SUBJECT: Augusta Regional Landfill – Scales & Scalehouse Project– Addendum No. 1

SCS Engineers is submitting this addendum to address initial questions from bidders on the Augusta Regional Landfill – Scales & Scalehouse Project (ITB# 2701)

**AUGUSTA REGIONAL LANDFILL
SCALES AND SCASLEHOUSE PROJECT**

13 of 34

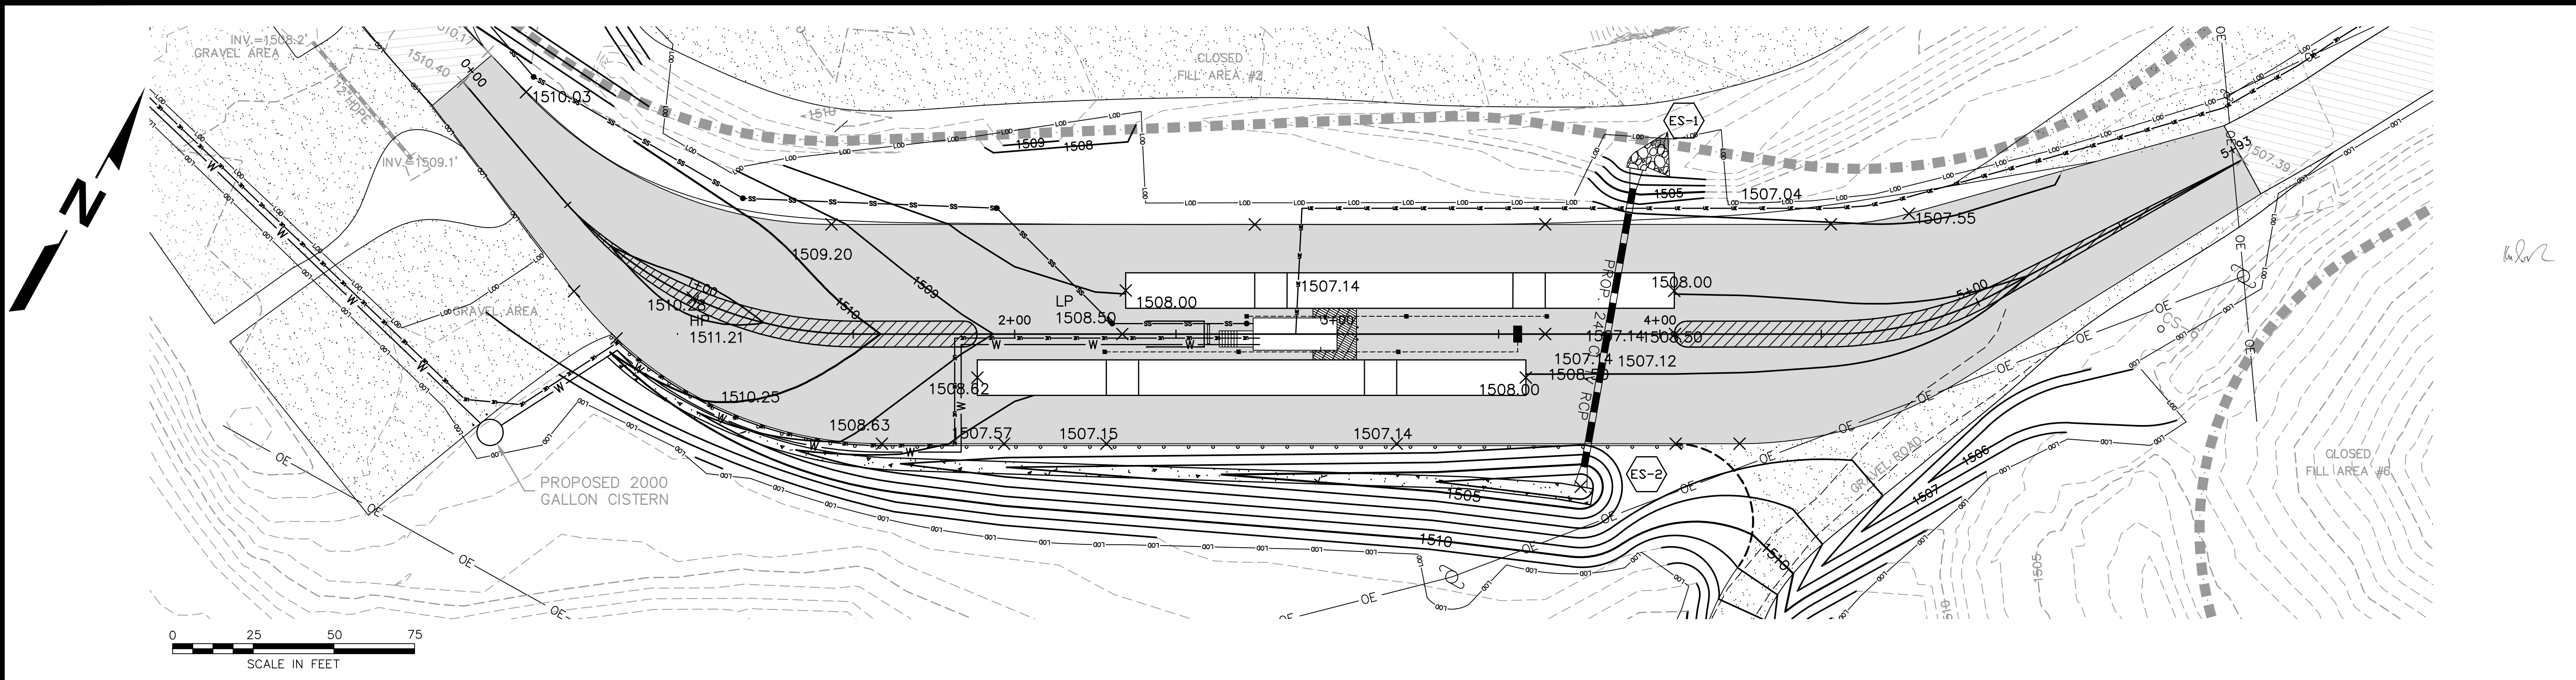
14. *“Clarify the 2" mill and overlay.”*

Response: See response to question #7. Limits of mill and overlay are provided on sheet 13.

9. DEMOLISH EXISTING SCALE HOUSE AFTER NEW SCALE HOUSE IS CONSTRUCTED, AND RESTORE SITE.
10. ASPHALT TO BE MILLED AND RESURFACED AS SHOWN ON THIS SHEET. EXISTING 1.5" TOPCOAT SHALL BE MILLED AND RESURFACED.

ROAD PLAN & PROFILE

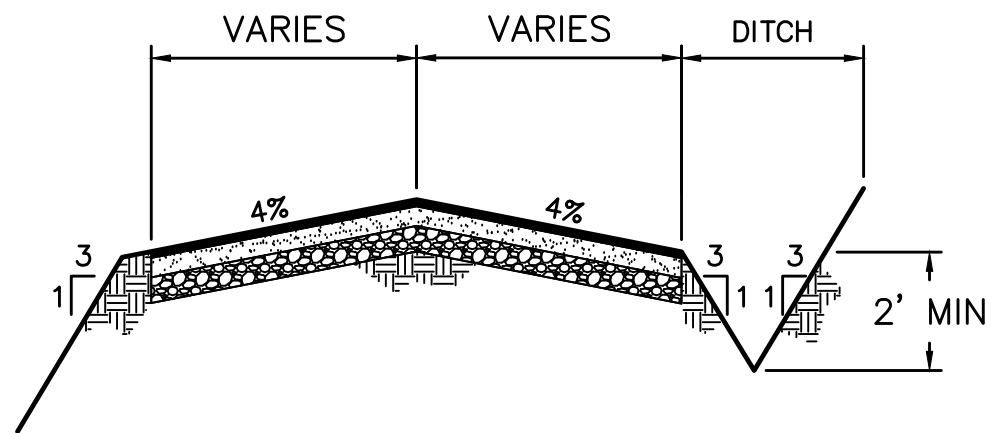
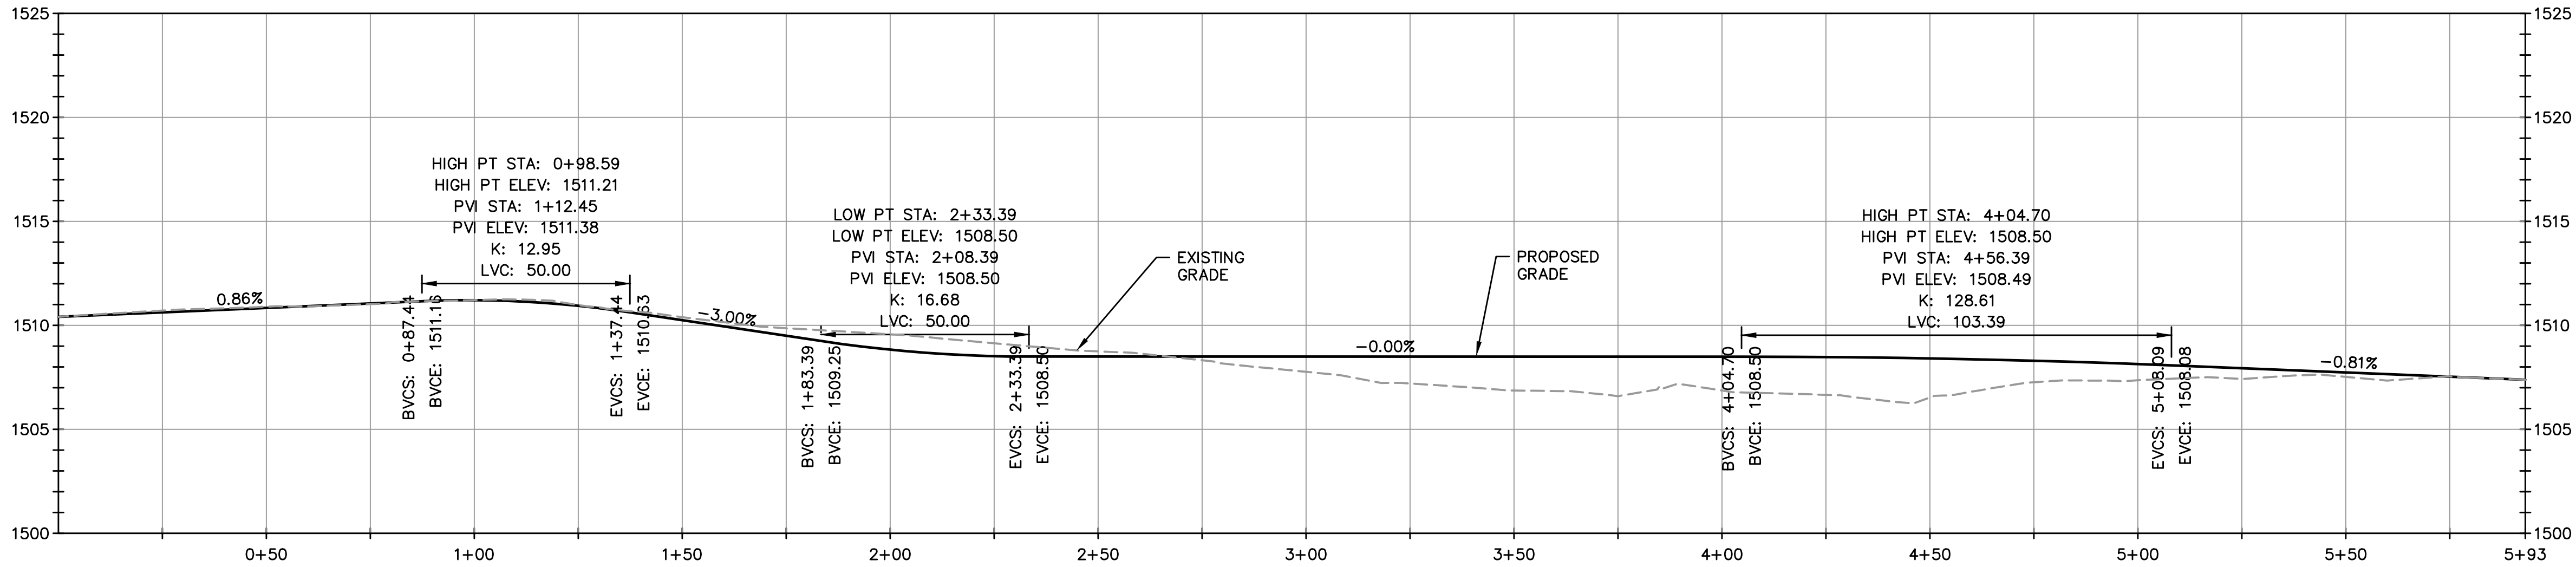
6. *“Please provide a stone/asphalt profile for the new pavement.”*

Response: A detail for the proposed asphalt section, can be found on the provided revised Sheet 19.

NOTE:
MINIMUM ASPHALT PAVEMENT SECTION SHALL BE:
- 8" AGGREGATE BASE OF 21A
- 3" BM-0.25.0D
- 2.5" IM-19.0D
- 1.5" SM-9.5D
